# Certification Specifications for European Technical Standard Orders (CS-ETSO) — Amendment 18

## Change Information

**CS-ETSO Amendment 18**

**Figure 1 TYPICAL LIFERAFT — ARRANGEMENT OF RETRO-REFLECTIVE TAPE**

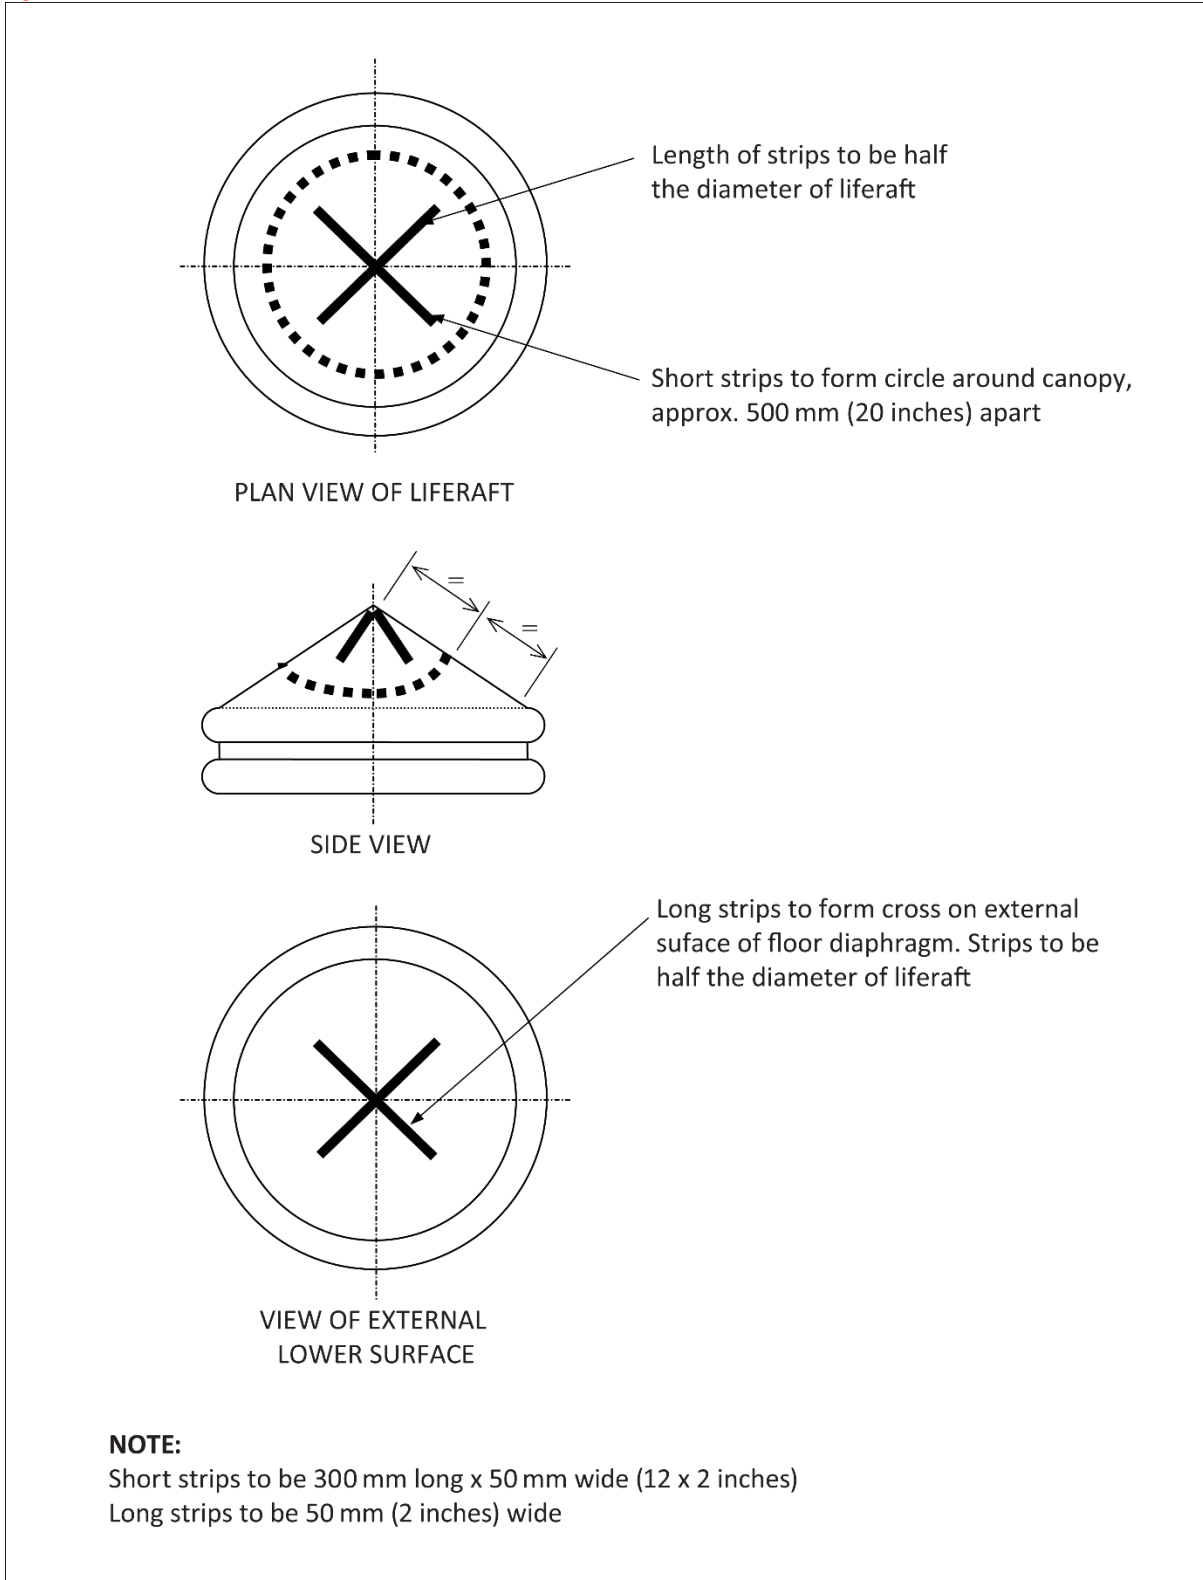
~~3.6.2 The arranged pattern of the retro-reflective material shall be generally as shown in Figure 1.~~
